# **CLARK SHAFT EVALUATION ADDENDUM**

UNIVERSITY OF TEXAS MD ANDERSON CANCER CENTER

B1511740  
DATE: 2017-06-09

Figure 1

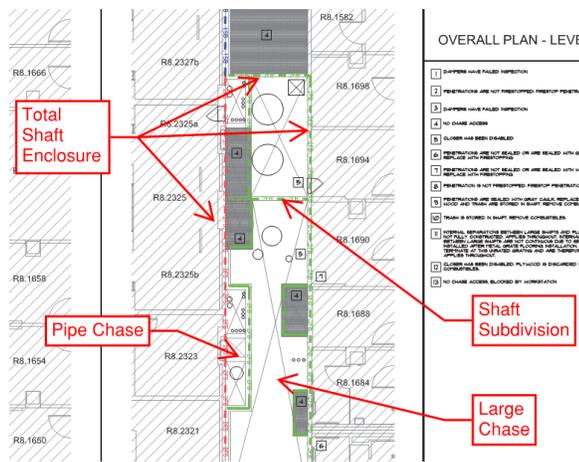
The findings and recommendations below describe both Total Shaft Enclosure and Shaft Subdivision deficiencies. Shaft Subdivision wall findings and recommendations include subdivision walls both between large chases and pipe chases. Figure 1 below provides an example floor to illustrate the language used in this report include TSE, SS, Pipe Chase, and Large Chase.
